SERVICE BULLETIN

No. 354B

Piper Aircraft Corporation

Subject: Fuel Selector Valve Lubrication
Reason for Revision: Revise Serial Numbers, announce replacement parts.

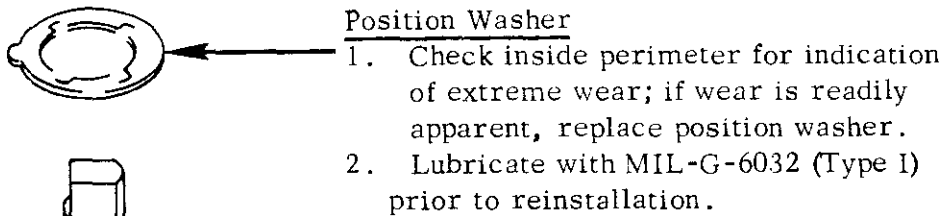
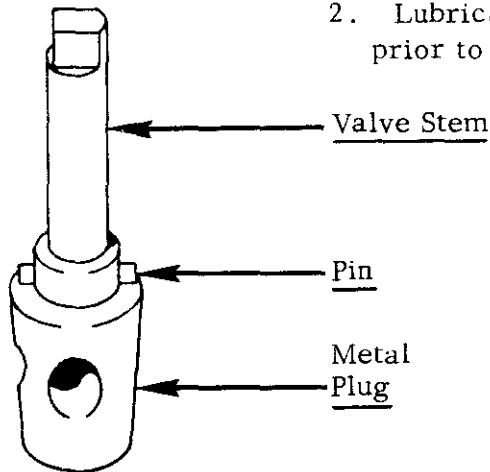
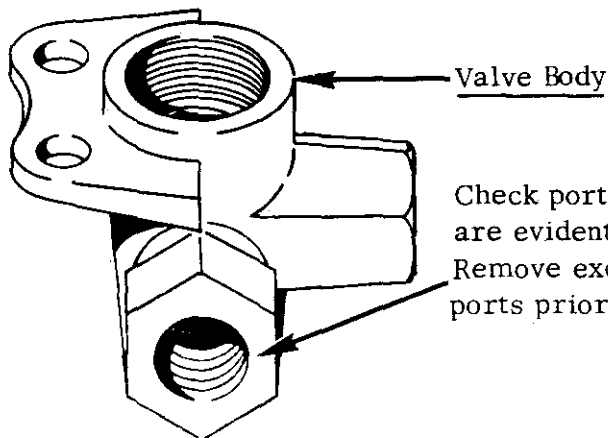
Brass Washer - counterbored; to reinstall properly, counterbored surface must face the position washer.

Position Washer
1. Check inside perimeter for indication of extreme wear; if wear is readily apparent, replace position washer.
2. Lubricate with MIL-G-6032 (Type I) prior to reinstallation.

Check ports for cracks; if cracks are evident, replace valve. Remove excess grease from ports prior to reinstallation.
